MINUTES
BOARD OF BUILDING STANDARDS/
ARCHITECTURAL BOARD OF REVIEW/SIGN REVIEW
REVIEW MEETING
CITY OF LAKEWOOD
12650 DETROIT AVENUE
AUDITORIUM
SEPTEMBER 11, 2025
5:30 P.M.
MEETING RECORDED
<https://www.lakewoodoh.gov/videos-2/>

13815/13901 Detroit Ave.
The View on Detroit East

Applicant proposes the review of a previously approved project for the construction of a mixed-use structure with parking to be evaluated under C3 zoning; ABR review under Chapter 1325. The project was approved at the May 13, 2021 meeting. (Page 5)

The View on Detroit East
 LAKEWOOD, OH
 MBC Job No. 21014-11

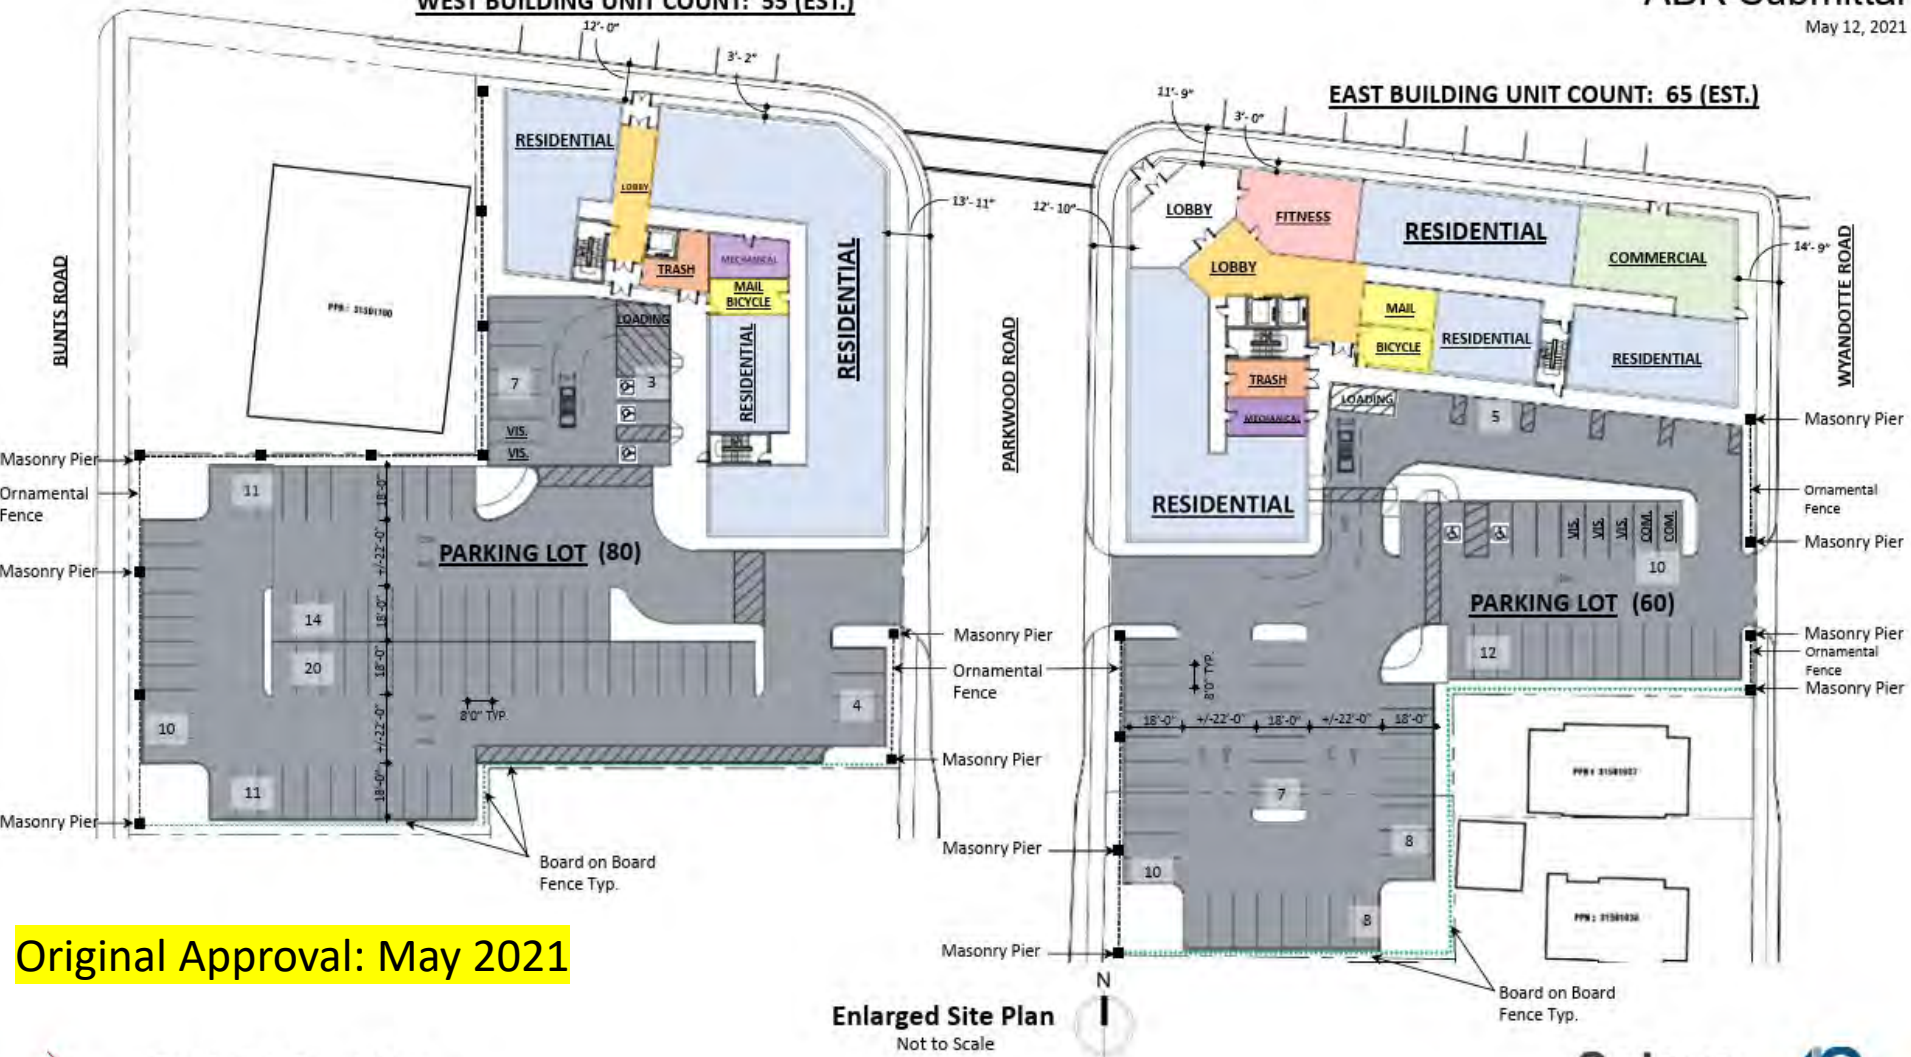
Ms. Cramer stated that the project was approved at the September 4, 2025 Planning Commission meeting. Matt Mendez, DiGeronimo Development, and Ron Tannenbaum, RDL Architects were present to explain the request. The members appreciated the revisions. Discussion began about EIFS colors, the verticals and returns between the windows, accent bay of the east building, planters were at a better scale, first floor residential window sills were raised, fiber cement color palette would match the EIFS, the members did not like the EIFS brick, reminded all of the Commercial Design Guidelines, members wanted a more robust landscaping for the parking lot buffer and more vertical plantings on the Bunts Road side,

suggested removing the planters mini fences and fill with brick or a single horizontal rail, planters needed to be integral to the buildings, suggested to focus on fiber cement (did not like EIFS). The members wanted to see four-sided elevations, a full scale site, accurate plans with updated landscaping, final materials and color options, a night rendering, and final material and colors selections for the façade. Administrative staff had no comments. Public comment was taken.

- Further details for the fiber cement trim, taller plantings on the side streets, final materials and colors for the entire buildings, depth of the window wells and materials, all elevations, connect the corner planter at the west building to the planter at the Detroit Avenue façade, updated landscaping, a night rendering, and wanted a full site plan that included the neighboring buildings.

**New Signage – Black Sheep 216 Smoke Shop
Dale Drummon**

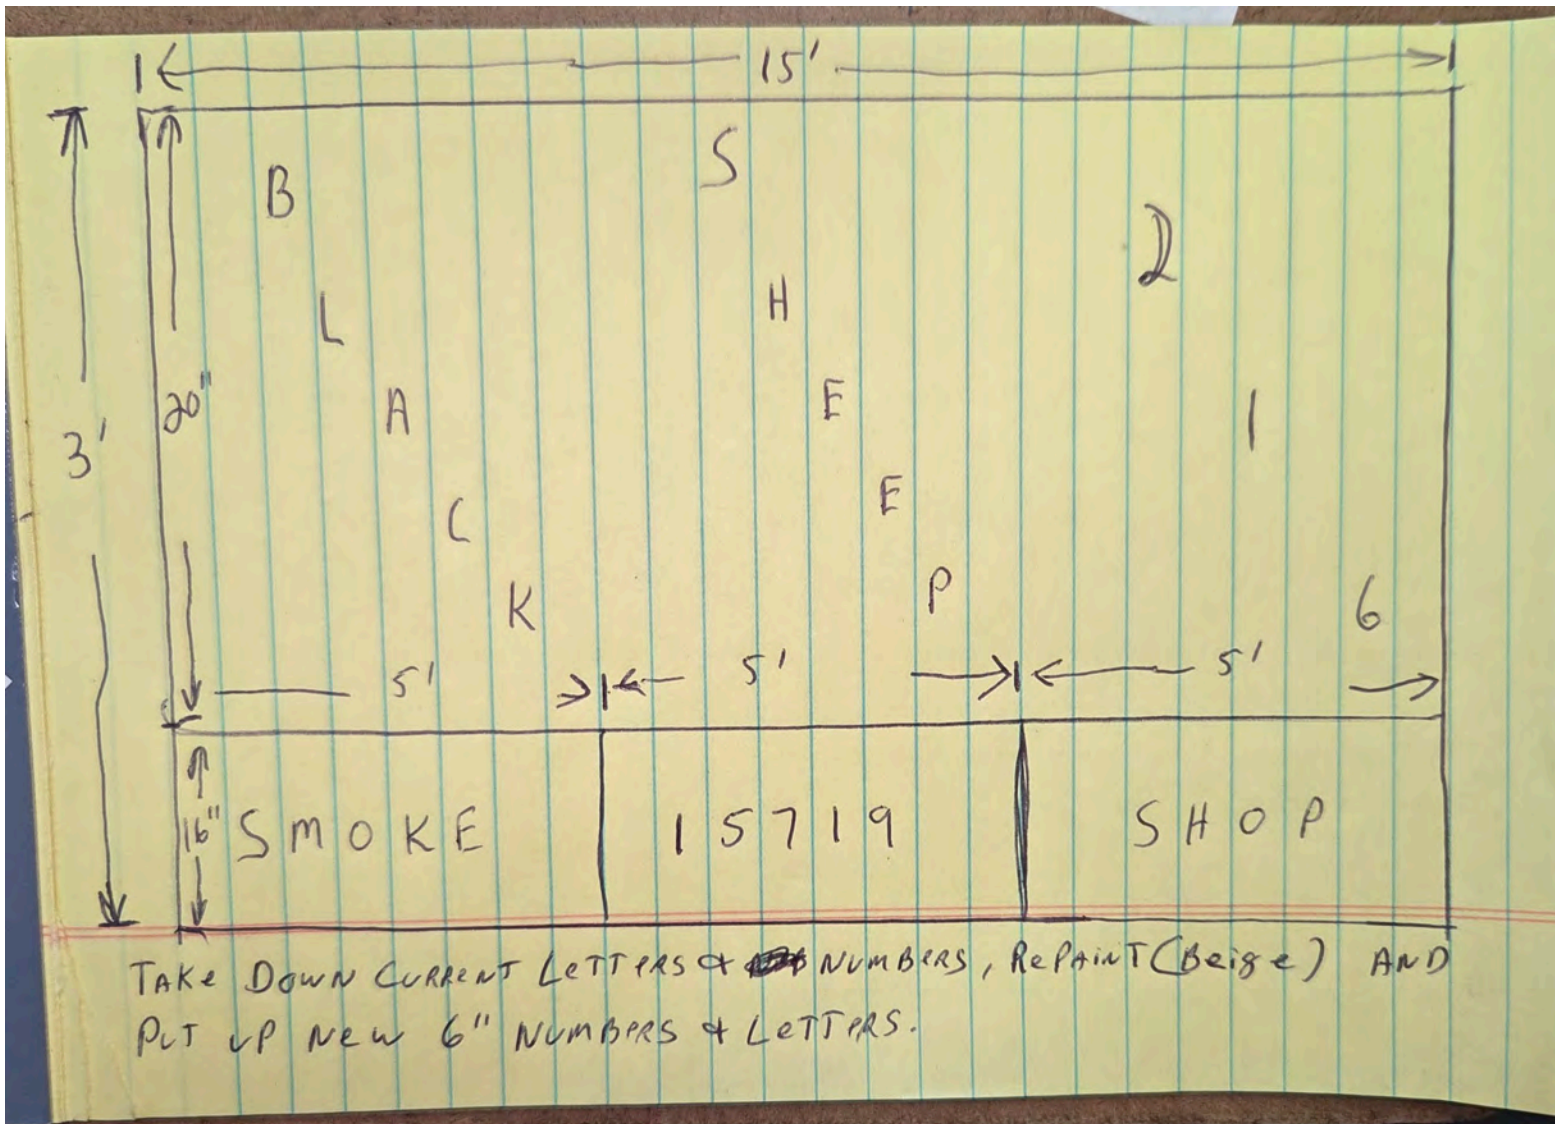
Dale Drummon, Black Sheep 216, applicant was present to explain the request. The members asked about placement of the letters and numbers, color, additional signage. Administrative staff had no comments. Public comment was closed as no one addressed the item.

- The "Black Sheep 216" text is horizontal in the center of the existing sign band.
- The lettering will be black.
- There will be no window graphics or vinyl on the windows.
- A revised drawing will be submitted to city staff for administrative approval.

**Barr, Jones & Associates** LLP
Attorneys at Law
www.barrjoneslegal.com
FAMILY LAW | DOMESTIC RELATIONS

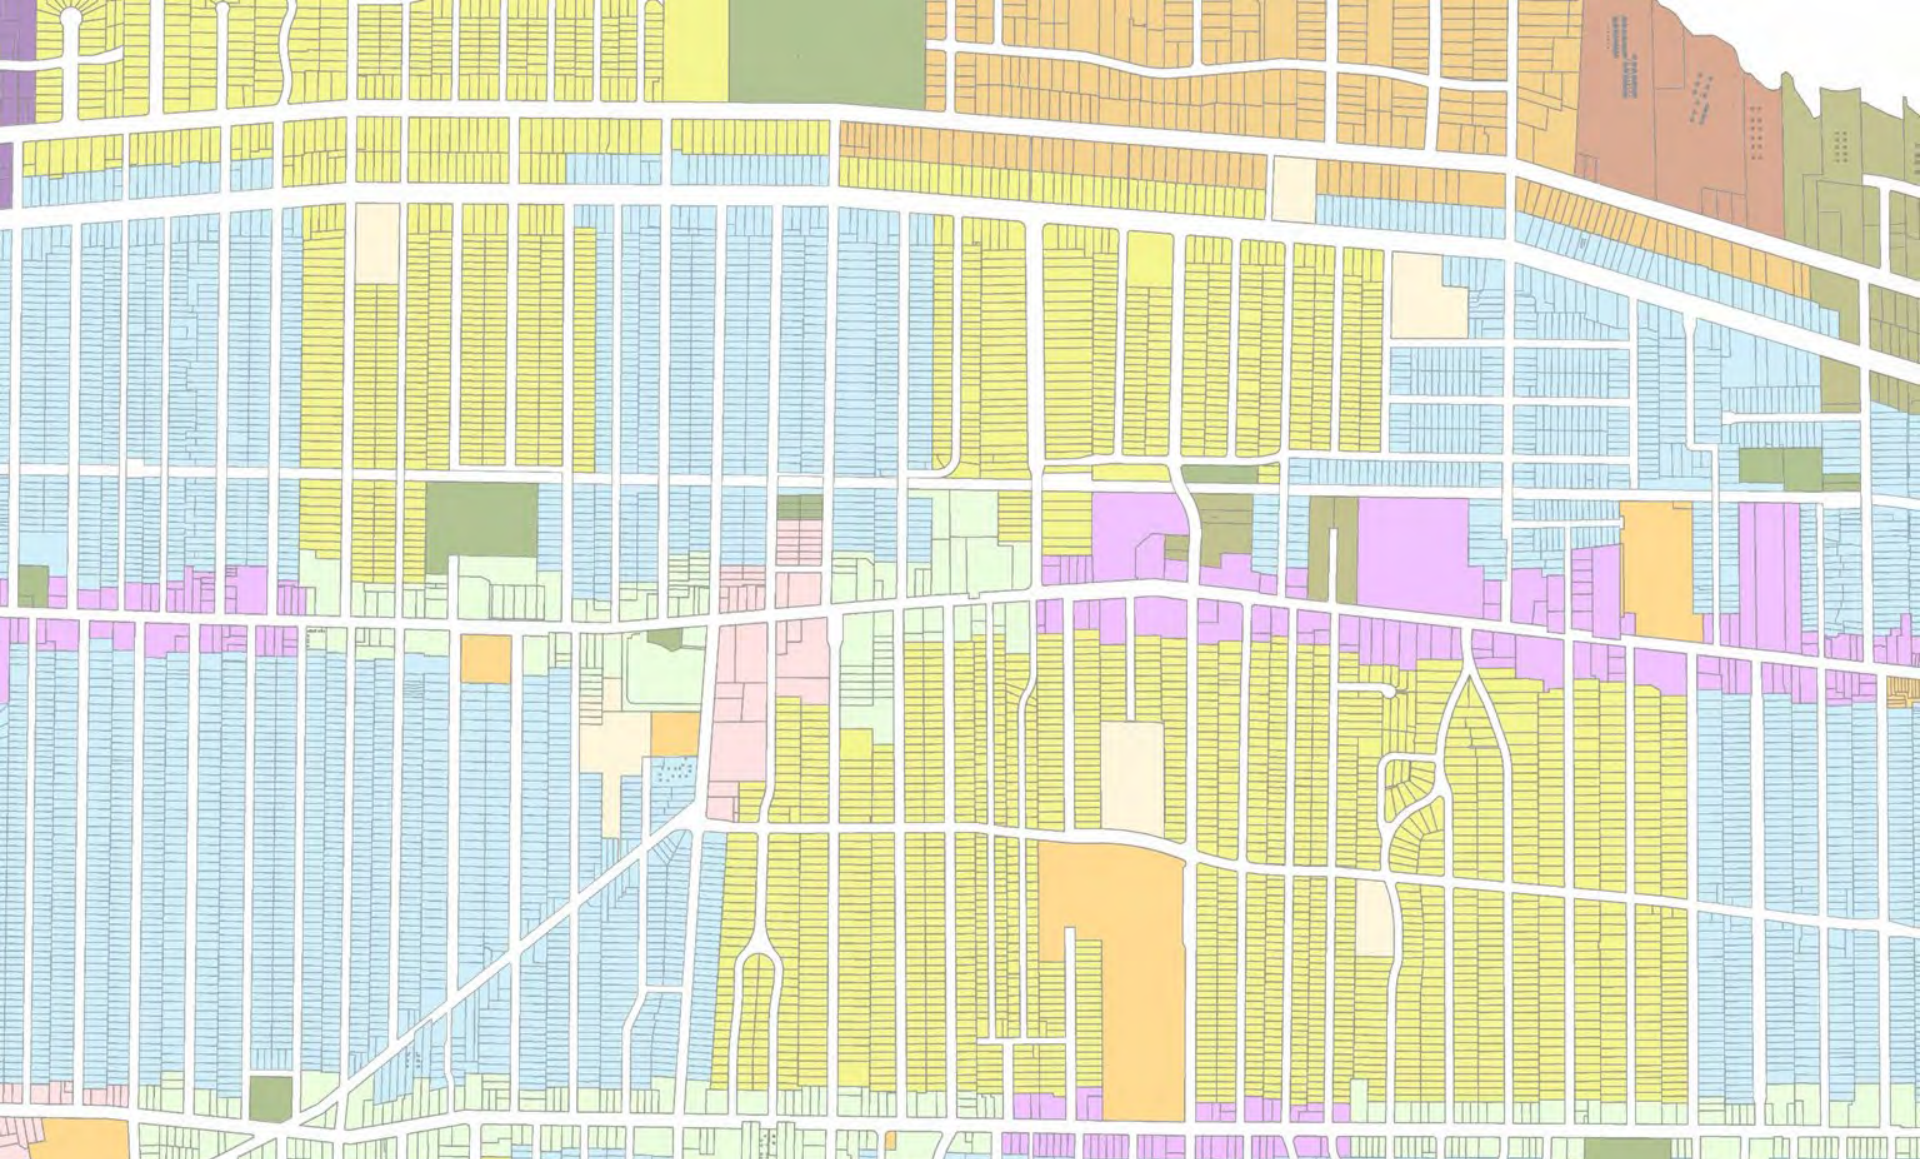
Meghan Brooks, Esq., representative was present to explain the request. Administrative staff said they were over the allowable sign square footage. The members wanted to see dimensions. Administrative staff had no additional comments. Public comment was closed as no one addressed the item.

- The existing door signage is to be removed.
- The new window graphic will be centered.
- The dimensions of all new graphics will be submitted to city staff for administrative approval.
